Approved SLD Dwg 407-71D General Arrangements

MANCHESTER CITY WOMEN'S 1ST TEAM FACILITIES

Latest SLD Dwg 407-71K General Arrangements

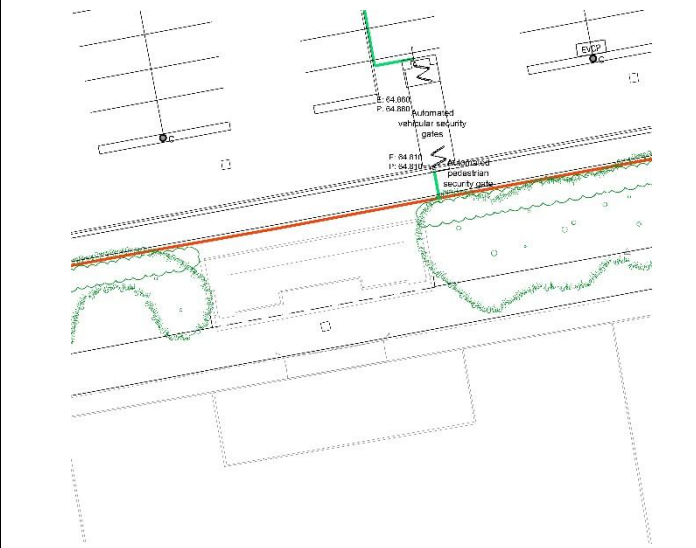
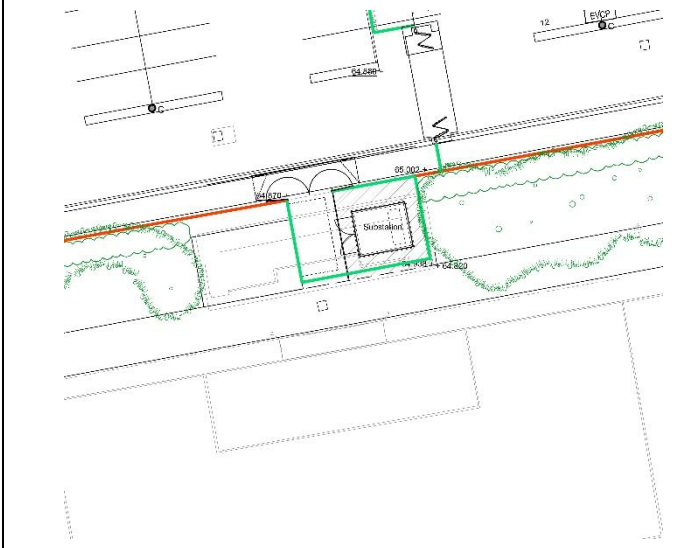
Item	Location	Change	Reason	Approved Layout	New Layout
1	External Plant	Concrete base increased to external plant located to the rear of the new building.	External plant layout updated for M&E purposes.

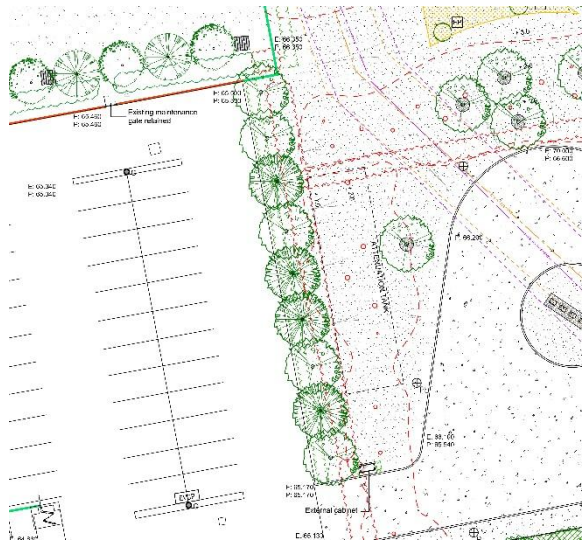
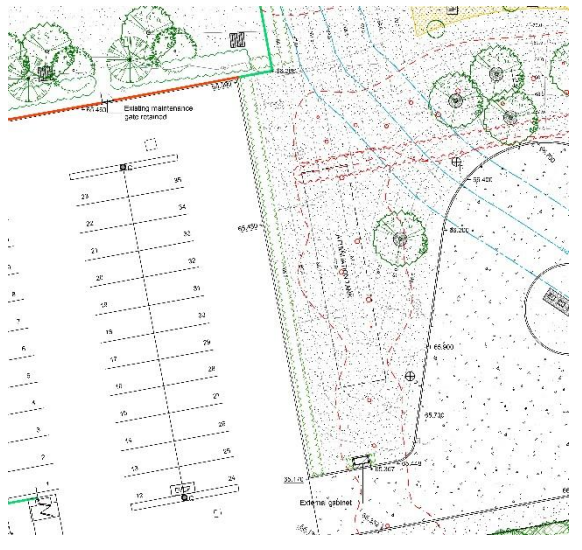
Item	Location	Change	Reason	Approved Layout	New Layout
2	Earthworks	Earthworks layout & levels amended.	Gas easement location updated to agreed proposals with UU. Cover levels reduced over easement from 2m+ to 1.2m maximum as specified by UU.

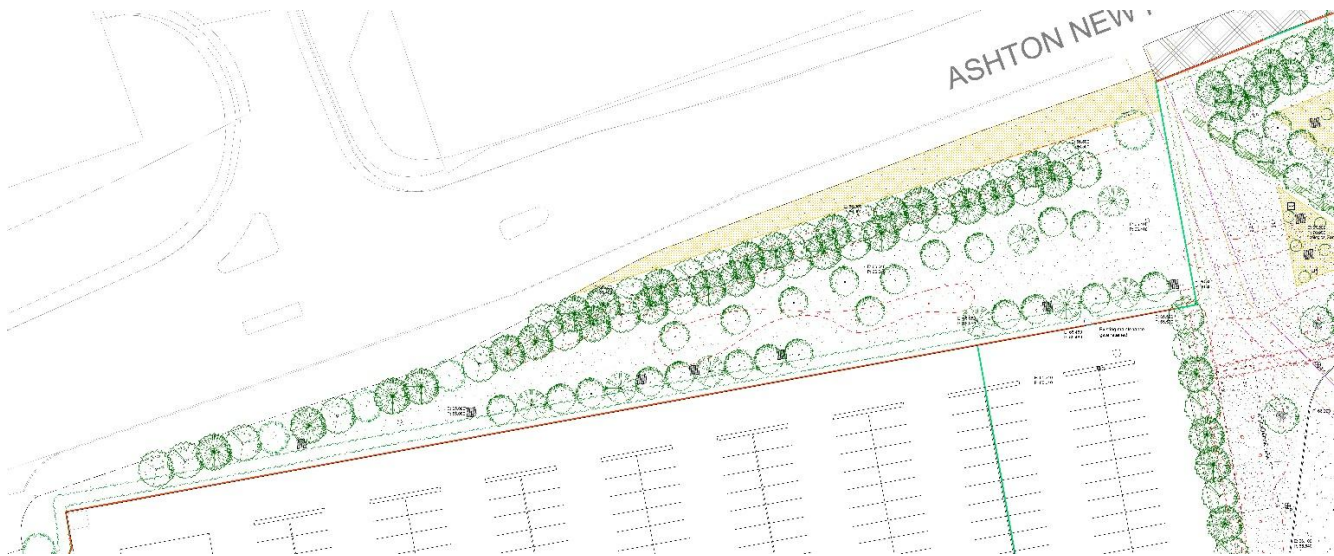
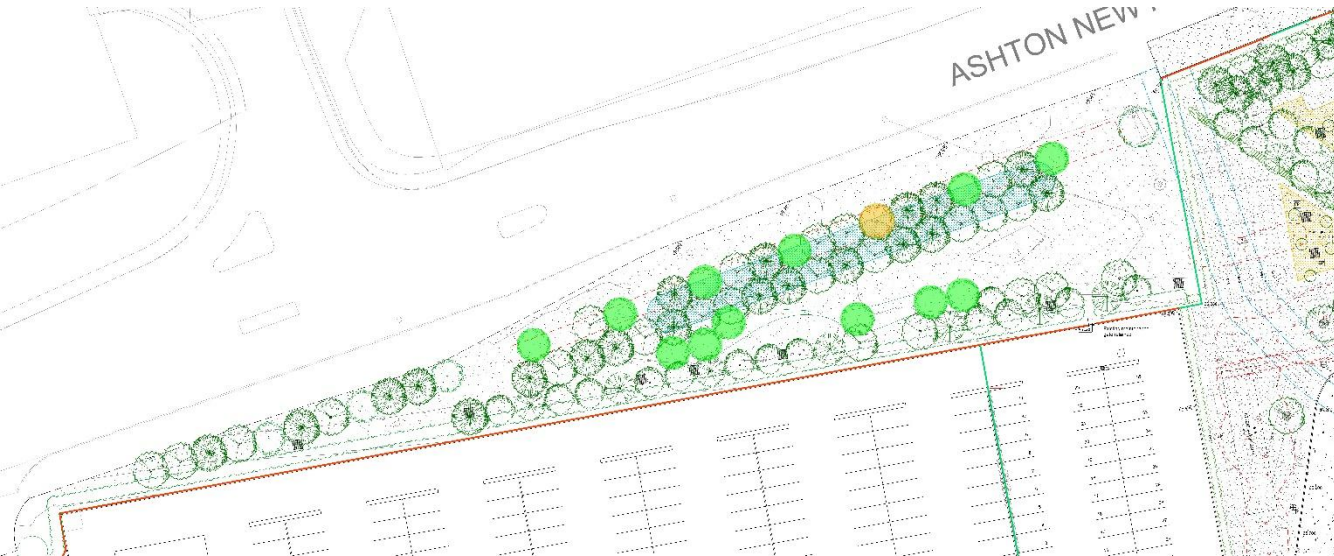
Item	Location	Change	Reason	Approved Layout	New Layout
3	Substation	Substation proposals included in landscape general arrangements.	The substation was introduced into the layout as part of the coordinated design process, ensuring project continuity and reflecting the arrangements agreed with the service provider.
